Project	IEEE 802.16 Broadband Wireless Access Working Group < http://ieee802.org/16 >	
Title	WirelessMAN-SCa Support for AAS	
Date Submitted	2004-03-17	
Source(s)	<p>Brian Eidson Conexant Systems, Inc. 9860 Scranton Rd, Suite 1000 San Diego, CA 92121 USA</p> <p>Robert Nelson MacPhy Technologies 1104 Pittsburgh Landing Richardson, TX 75080</p>	<p>Voice: +1 858 713-4720 Fax: +1 858 713-3555 mailto: brian.eidson@conexant.com</p> <p>Voice: 972-239-9224 Fax: 972-671-1455 mailto: bob_nelson@ieee.org</p>
Re:	Sponsor ballot on document <i>IEEE P802.16REVd/D3-2004</i>	
Abstract	Provides text describing support for AAS under WirelessMAN-SCa	
Purpose	For consideration of adoption during Sponsor Ballot Resolution for REVd/D3.	
Notice	This document has been prepared to assist IEEE 802.16. It is offered as a basis for discussion and is not binding on the contributing individual(s) or organization(s). The material in this document is subject to change in form and content after further study. The contributor(s) reserve(s) the right to add, amend or withdraw material contained herein.

WirelessMAN-SCa Support of AAS

Brian Eidson, Conexant
Bob Nelson, MacPhy Technologies

Figure 1—MAC frame contents with AAS elements

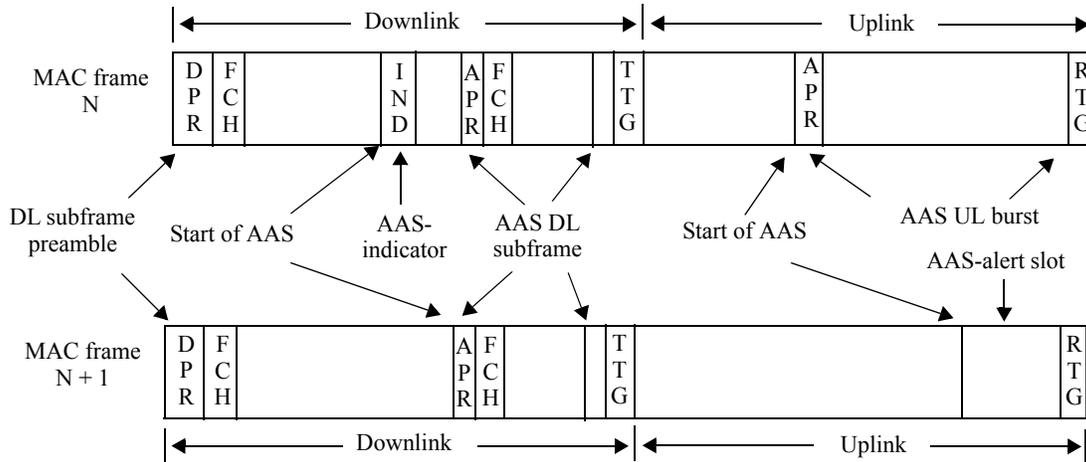
Elements associated with AAS transmission include an AAS-indicator, an AAS-alert slot, AAS-formatted downlink subframes, and AAS-formatted uplink bursts. An example of the content of MAC frames when AAS elements are included is presented in Figure 1.
